IEEE P802.3dm™/D2.0

Green indicates changes for supporting 1 Gb/s LS in addition to those for adding a 7.5 Gb/s HS rate]

Draft Standard for Ethernet Amendment: Physical Layer Specifications and Management Parameters for Asymmetrical Electrical Automotive Ethernet

Figure 192-5—S_TX RS Transmission Ordering

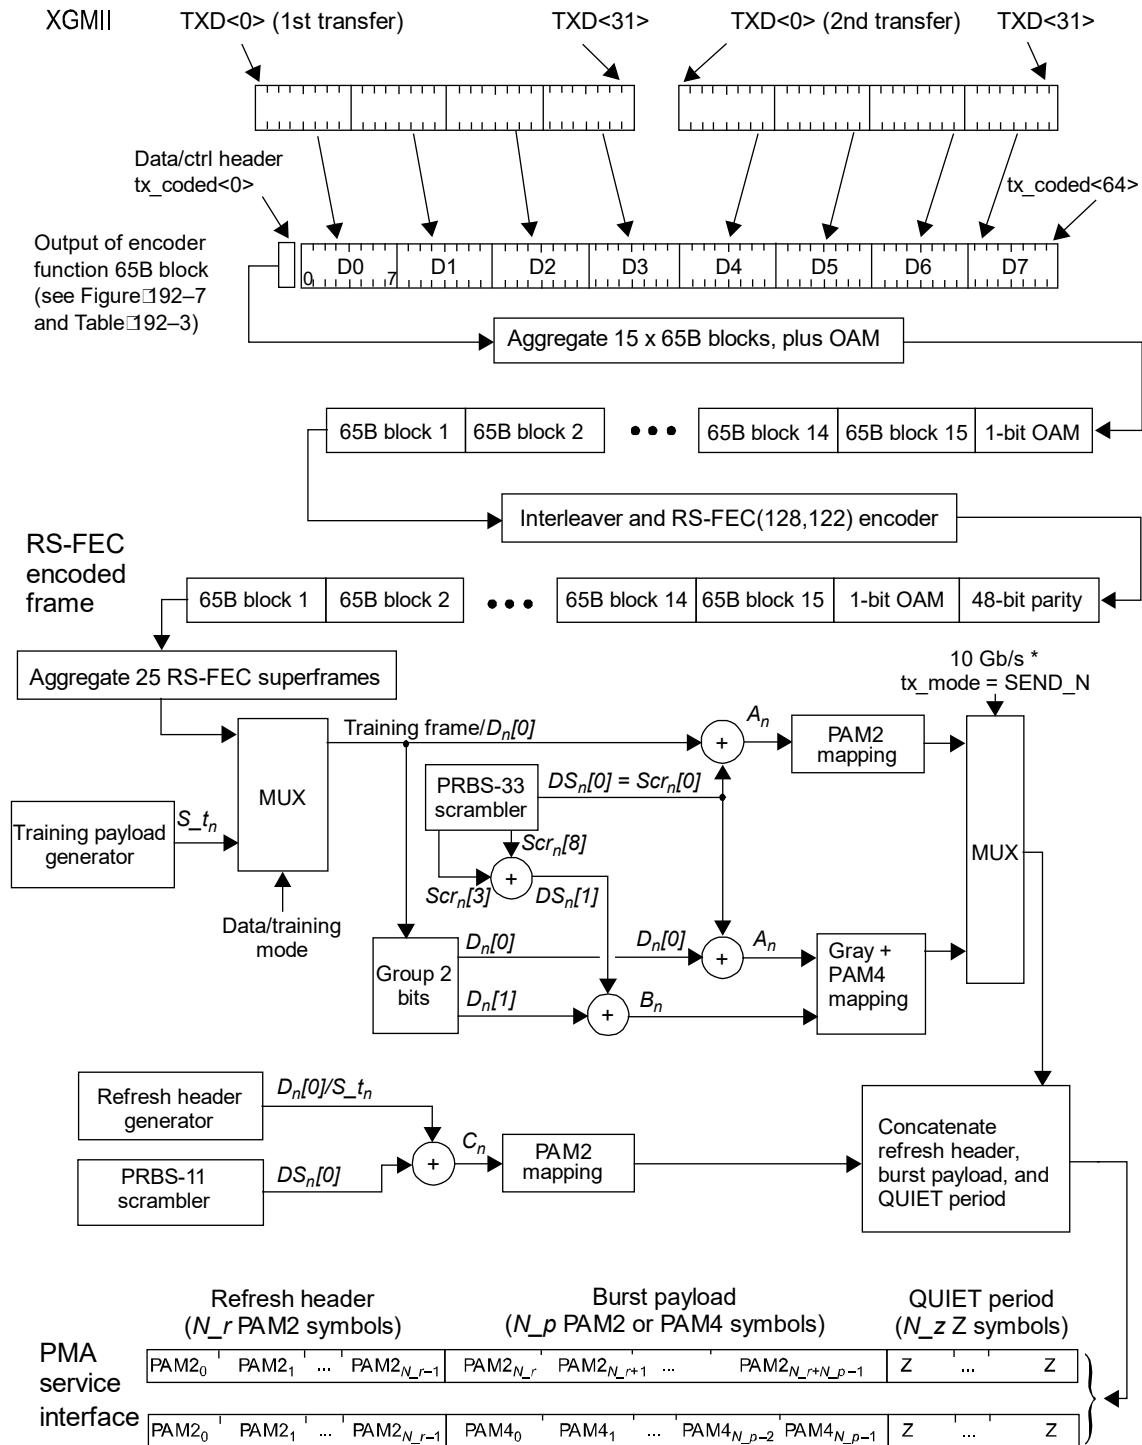
[Note to Editor: A separate version of the figure should be added for the 1 Gb/s LS. Putting both in the same figure could be confusing to the reader. The edits to current Figure 192-5 to create the 1 Gb/s version are as follows:

1. For the FEC, use an RS-FEC(128,122) encoder,
2. The output of the RS-FEC encoder is fifteen 65B blocks, 1 OAM bit and a 48-bit parity (i.e., similar to what's in Figure 192-6 with the same RS-FEC),

3. Similarly similar to Figure 192-6, add an aggregator block between the RS-FEC-encoded frame and the mux. Specifically, the aggregator block should be labeled “Aggregate 6 RS-FEC superframes”.
4. If the PMA service interface is retained in these figures, it should be re-drawn similar to Figure 192-6.

Figure 192-12—S_RX PCS Receive bit ordering

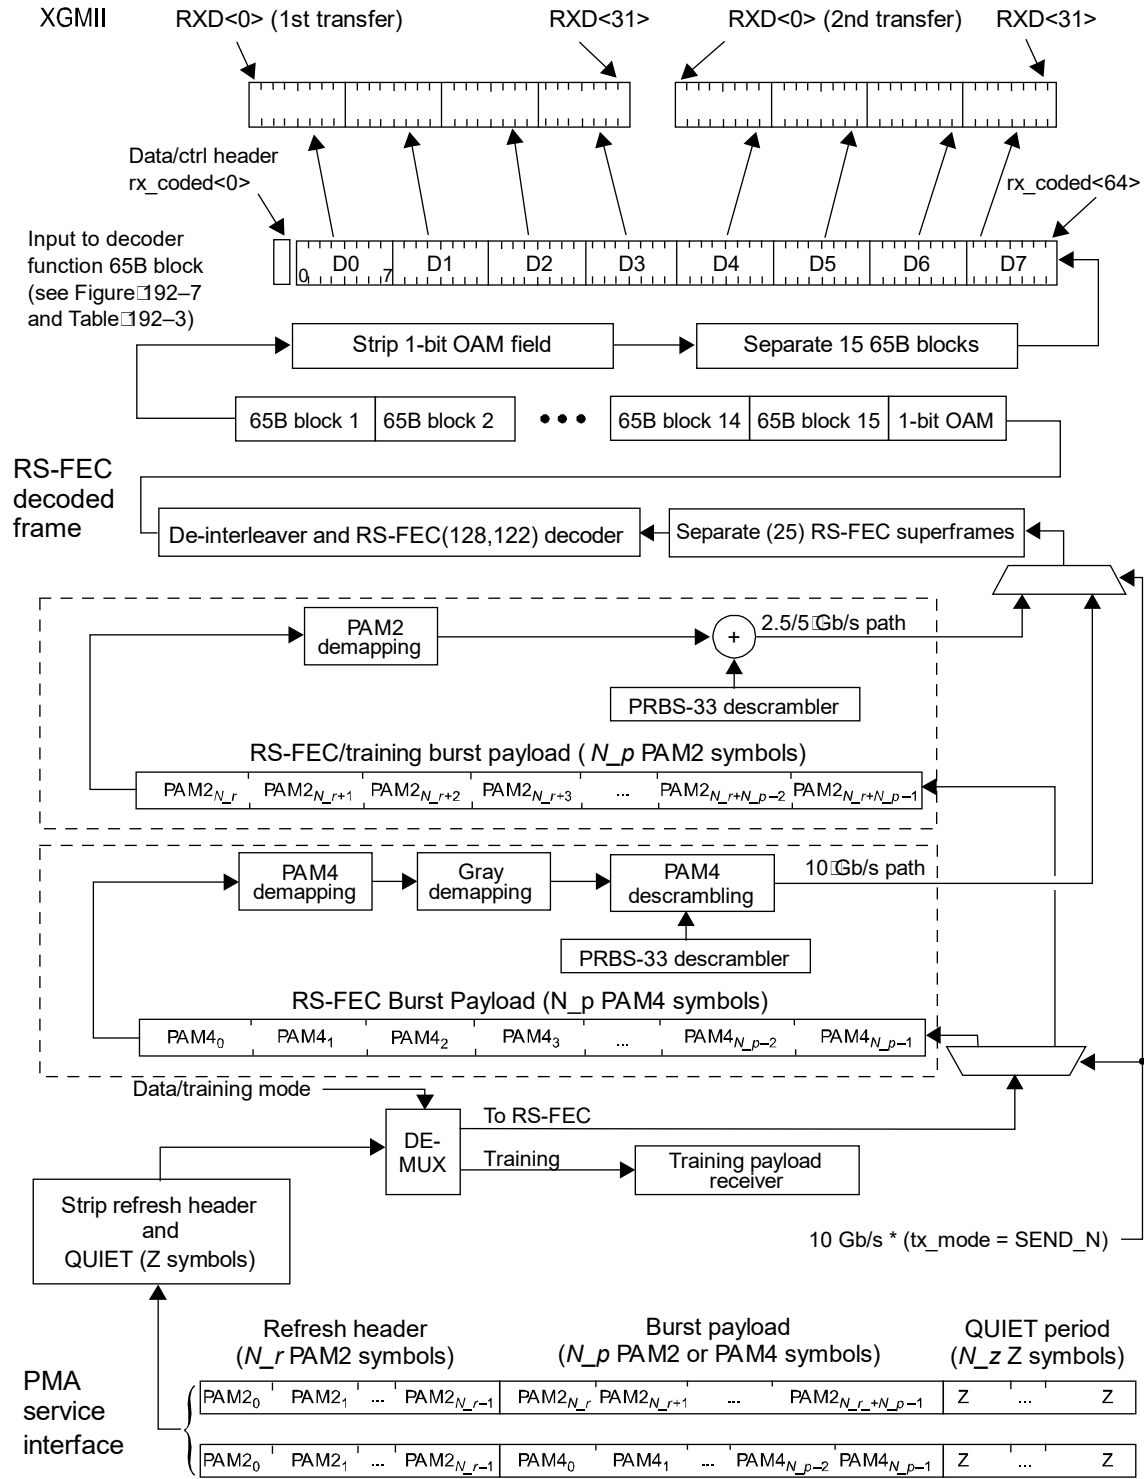
[Note to Editor: A separate version of the figure should be added for the 1 Gb/s LS. Putting both in the same figure could be confusing to the reader. The edits to current Figure 192-5 to create the 1 Gb/s version are as follows:

1. Replace “RS-FEC(130,124) decoder” with “De-interleaver and RS-FEC(128-122) decoder”
2. Add a “Separate (6) RS-FEC superframes” block ahead of the De-interleaver and RS-FEC decoder block
3. The output of the RS-FEC decoder is fifteen 65B blocks, 1 OAM bit and a 48-bit parity (i.e., similar to what’s in Figure 192-13 with the same RS-FEC).

4. **If the PMA service interface is retained in these figures, it should be re-drawn similar to Figure 192-13.**

Figure 192-hh – Illustration of the data burst payload structure

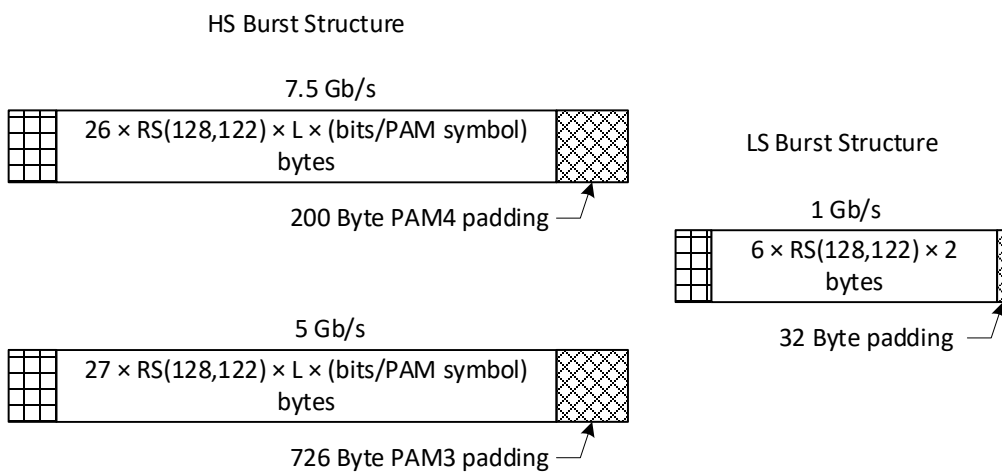
[Note to Editor: Remove the 25-FEC superframe block structure from within the Data burst payload and add the following new figure.]

The burst payload structures are illustrated in Figure 192-hh, with the data burst payload information summarized in Table 192-h. The data burst structures associated with 1 Gb/s LS include padding in the data burst payload area and

there is capacity remaining in the last RS-FEC block of the data payload area. The content of the unused RS-FEC block payload bits and the padding fields are user defined and outside the scope of IEEE 802.3.

Figure 192-33—Transmit Power Spectral Density for 5 G/s MAC data rate, upper and lower masks

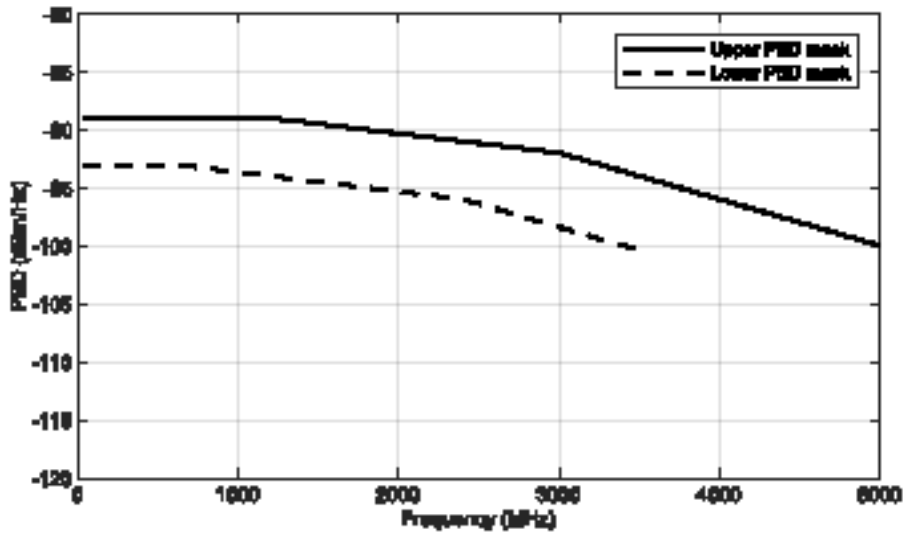
[Note to Editor: Add “1 Gb/s” to the caption of Figure 192-33.]

Figure 192-xx – Transmit Power Spectral Density for 7.5 Gb/s MAC data rate, upper and lower masks

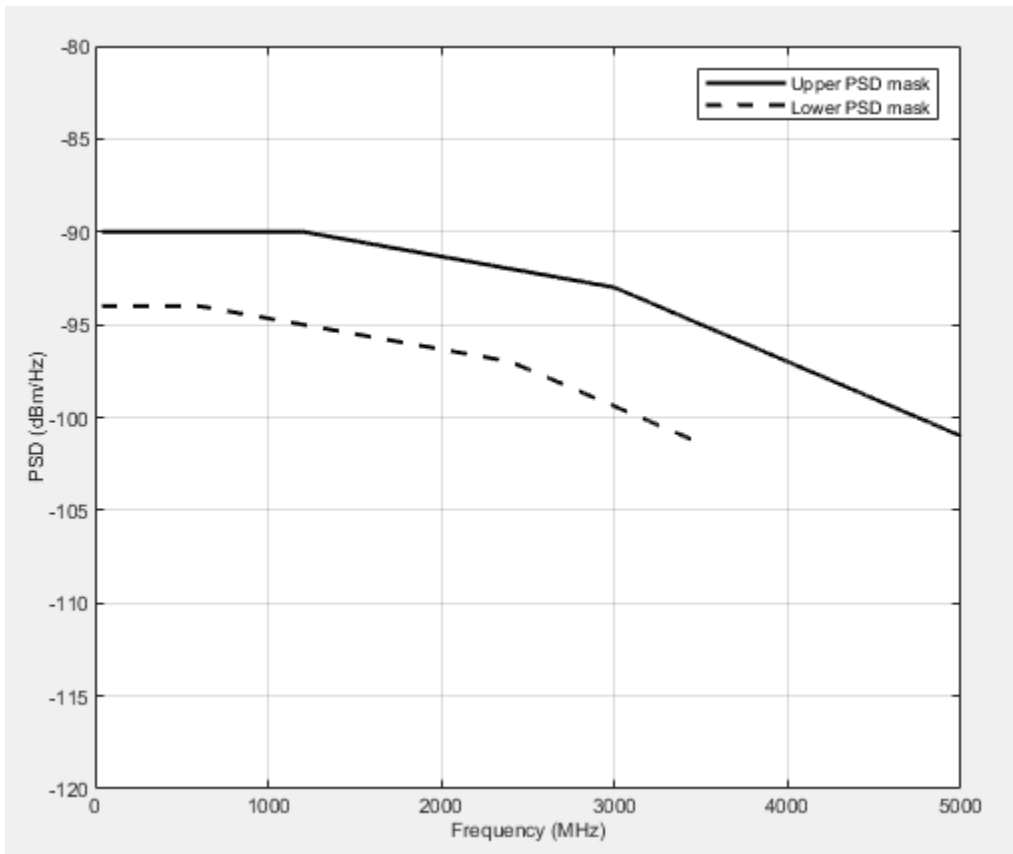
[Note to Editor: This PSD plot for 7.5 Gb/s was generated using George’s format with S=1 and K=1.]

[Note to Editor: This PSD plot applies to both 7.5 Gb/s and 5 Gb/s + 1 Gb/s LS.]

Figure 192-34—Transmitter Power Spectral Density for 10 Gb/s MAC data rate, upper and lower masks

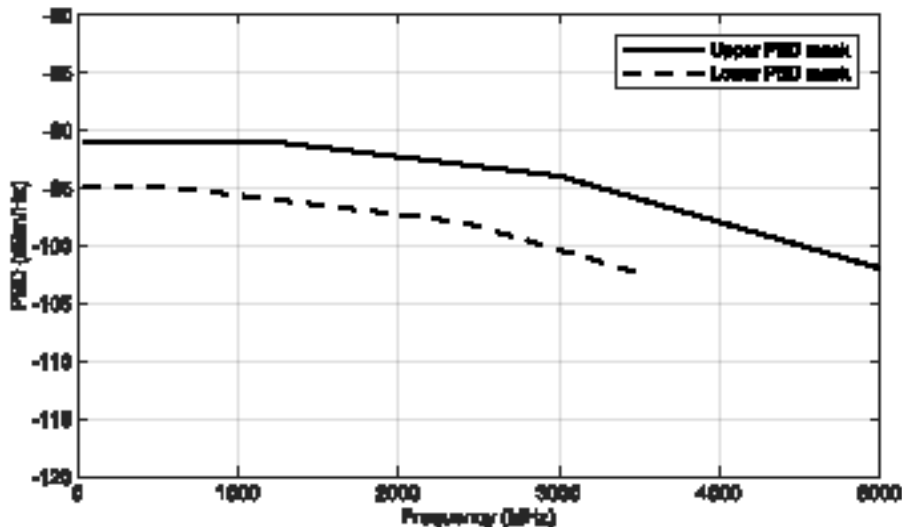
[Note to Editor: This PSD plot applies to both 10 Gb/s and 7.5 Gb/s + 1 Gb/s LS.]
